We appreciate Dr. Morris for the careful review of our paper and the constructive comments.

### **Reply to the specific comments**

Figure 15 Fitting relation of  $Q_{b*}$  and  $B_s h_s^{1.5}$

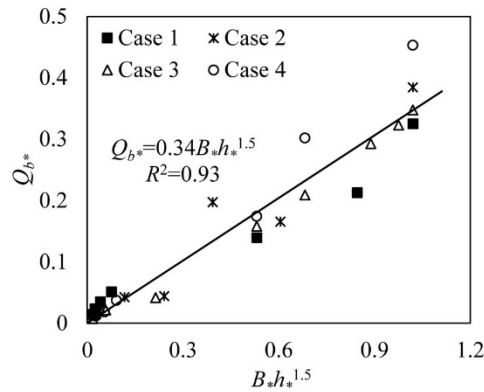
3. Ln 16 - choosing a fixed discharge coefficient for a weir shape that changes during the erosion process, and for which

Re: In Fig. 15, almost all the data are selected from the headcut retreat stage. So most of the weir height is larger than zero. Although the discharge coefficient varies with the ratio of the weir height to the overflow depth, its variation is in a limited range and the deduced discharge coefficient is in an average meaning. So there exist deviation between the scattered points and the fitting line.

**Helix flow in dam break processes**

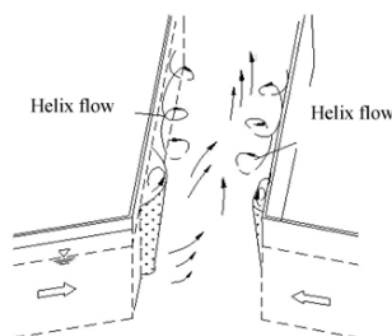
7. Ln 47 - you mean vortex rather than spiral flow?

Re: Here the spiral flow indicates the helix flow shown in the following figure. The author (Zhang et al, 2009) found that the upstream of the breach is bell-shaped, and helix flows exist on both sides of the breach. This kind of flow pattern could be considered as the convergence of three currents: the left bend flow, central straight flow, and the right bend flow.

**Figure 7 Breach widening process**

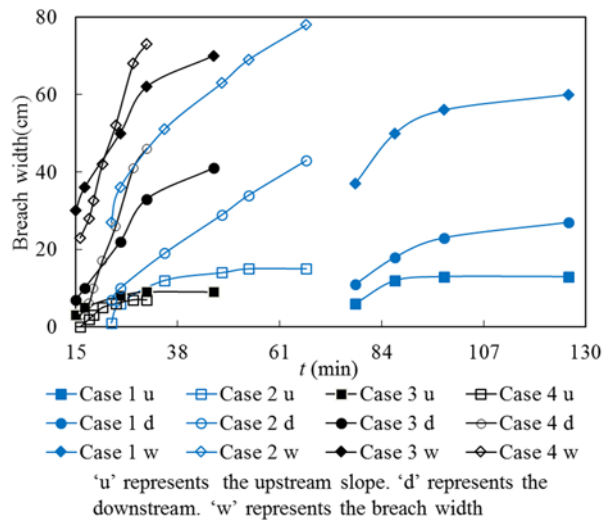
10. Ln 148-150 - the approach flow conditions offer a whole area of research in relation to breach formation that could be / should be analysed!

Re: Thank you very much for your suggestion. This part has been reorganized as follows in Ln 156-162:

The breach widening process is shown in Fig. 7. It can be seen that initially, the migration rate of the upstream and downstream side slope of the breach was similar. But afterwards, the downstream side was eroded faster. This can be explained by the flow structures shown in Fig. 3f. The main breaching flow concentrates near the downstream side slope and eroded its toe. Fig. 8 shows the calculated flow field near the breach of Case 2 when the breach width is about 40 cm using the following 2D depth-averaged numerical model. The flow velocity near the downstream side is larger than that near the upstream side. Meanwhile, around the downstream side, the flow velocity near the toe of the land region is larger than that of the river region. The flow structure corresponds well with the final breach form shown in Fig. 9.
